SCHOOL FOR MARINE SCIENCE AND TECHNOLOGY

FROM: Steve Cadrin, Independent Reviewer

RE: Peer Review of "The Great Red Snapper Count: Estimating the Absolute Abundance of Red Snapper in the U.S Gulf of Mexico"

Figure 1. Red snapper abundance in the eastern and western areas of the northern Gulf of Mexico estimated from the Great Red Snapper Count (GRSC) and the SEDAR52 stock assessment (SEDAR 2018; unfished, 1870-2016 estimates, 2017-2020 projections at the overfishing limit).

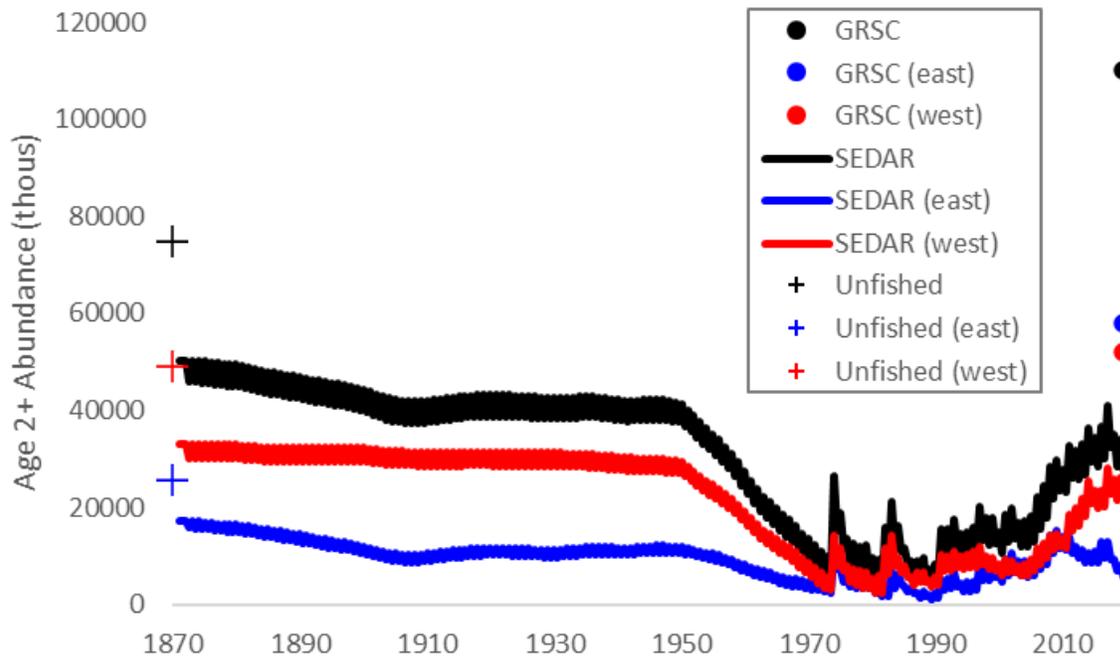
The estimate of age-2 red snapper abundance in late 2019 was 110 million with a CV of 11%. If the CV is correct, abundance estimates are appropriately reported in significant digits of 10-million. Because of the large area of uncharacterized habitat, those strata contributed the most to the stock-wide abundance estimate. As reported in section II.F.2.c (estimate reconciliation) the estimate of abundance is substantially greater than contemporary estimates from the SEDAR52 stock assessment. The stock-wide estimate of age-2+ abundance is about four times greater than the projected 2019 abundance and greater than estimates of unfished stock abundance from the SEDAR52 stock assessment (Figure 1. below; SEDAR 2018; age-2+ estimates and projections from M. Smith).

The estimated spatial distribution of the resource is relatively even (53% eastern regions, 47% western regions), which is substantially different than the spatial distribution estimated by the SEDAR52 assessment (21% eastern area, 79% western area; Figure 1). Stock assessments are typically better at assimilating data and estimating relative stock status than they are at estimating absolute stock size, but the different perspectives of spatial distribution raises concerns that the apparently even spatial distribution may result from unequal sampling efficiencies of the different sampling methods used in each region. Most hard bottom was in the Florida strata, sampled with optic methods, but most oil and gas platforms were in western region, sampled with acoustic methods. Estimates of abundance assumed 100% detection, but paired comparisons show that acoustic sampling has much lower detection. Therefore, abundance in western regions may be substantially underestimated, and including them in an integrated stock assessment may impose conflicting information on scale.
